BUILDING DEPARTMENT PERMIT

PERMIT ISSUED
Permit Number: 041751
APR 13 2005
CITY OF PORTLAND

has permission to New Single Family Home

AT 417 Island Ave, P.I. Call 090 0010001

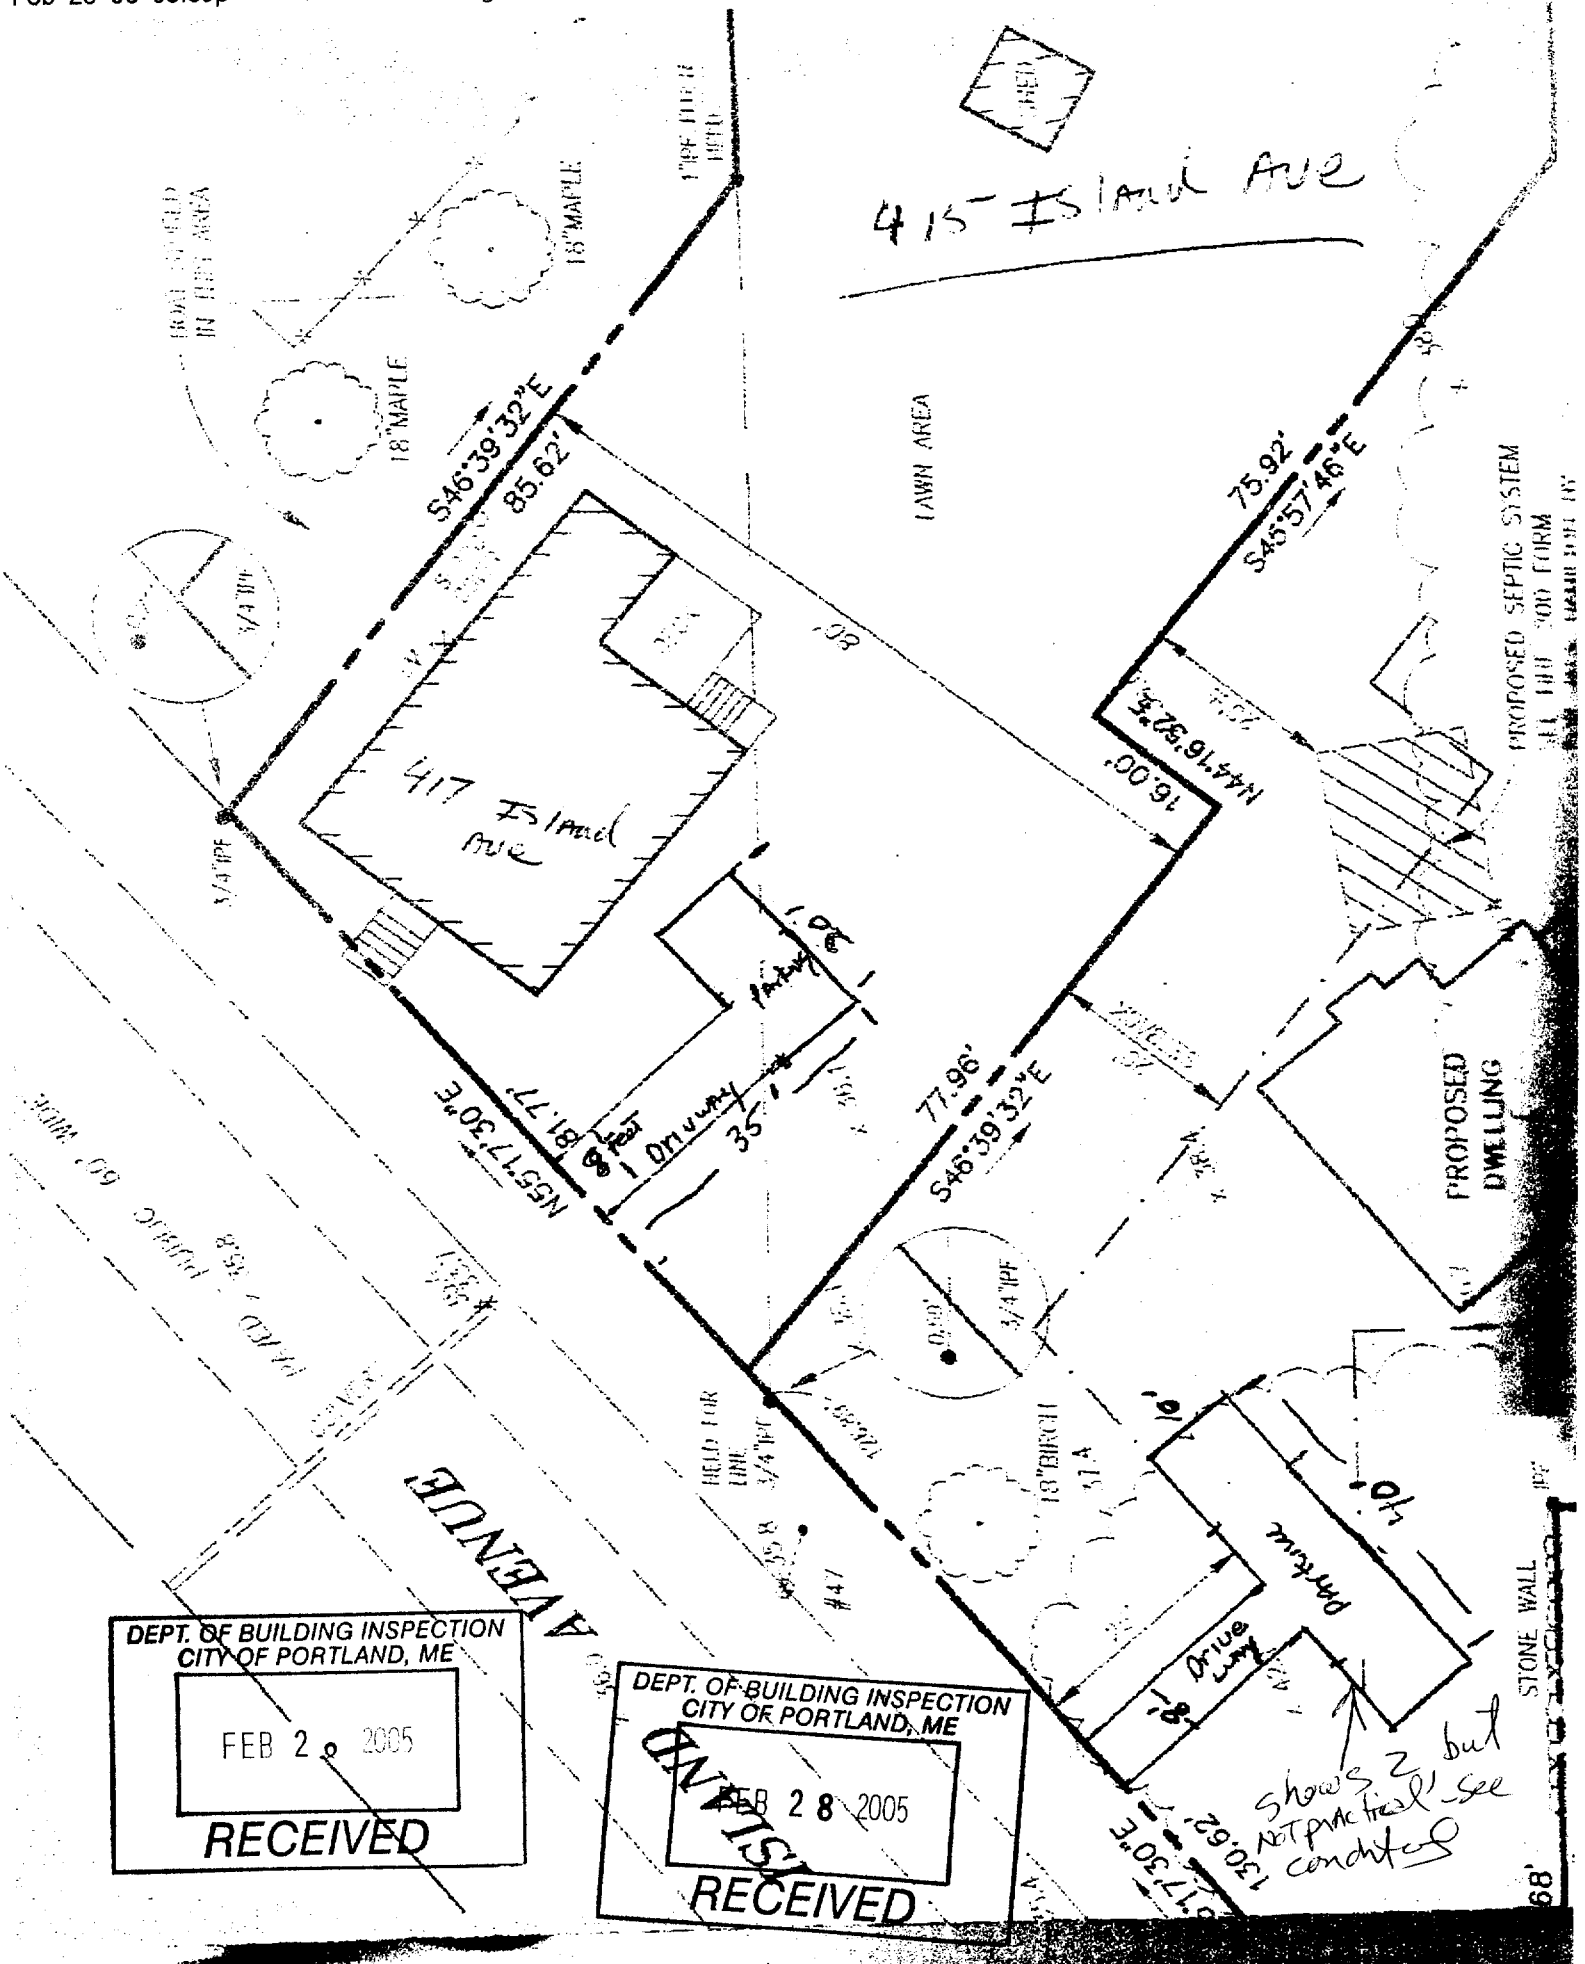
Section 14-145 requires a **minimum** lot width of eighty (80) feet. The existing house lot is only 70 feet in width. I am unable to accurately measure the newly created lot because the submitted plans are not to scale. This office requires scaled site plans showing the exact location of the new structure. The plans submitted show an approximate location. This office needs more exact information that is scaleable.

Section 14-336(a) states that all required parking shall not be located within the required front yard setback. The IR-2 zone requires a 25' **minimum** front setback or no less than the average depth of the buildings on either side of the lot. **Your** plans are not complete enough to determine that you may use the averaging provision. Currently you are showing that the two required parking spaces are located within 25 feet of the front property line. This office also will need to see that the existing house lot has at least one parking space properly located on that lot. Currently no parking space is denoted.

On the islands, height is determined by measuring from pre-development grades as defined under 14-47 *Building, height of*: The submitted plans show no grades whatsoever. There is a requirement of submittal to show predevelopment grades compared to post development grades. No grades are shown on your submitted plans. Required building heights cannot be affirmed.

It is also important that all plans are scaleable. All plans must match. Site plans shall reflect exactly what **is** shown on the building plans. Currently both sets of plans are different. It is also noted that the current building construction plans show a daylight basement in the rear. It is my understanding that there is to be no daylight basement. This makes you submitted building plans defective. It is important to submit plans that reflect exactly where and what you intend to building. Once a permit can be issued, our field inspectors will be checking to be sure that is being built is what was approved. If there are any changes to an approved permit, an amendment application is required to show those changes and to be approved **prior** to their implementation.
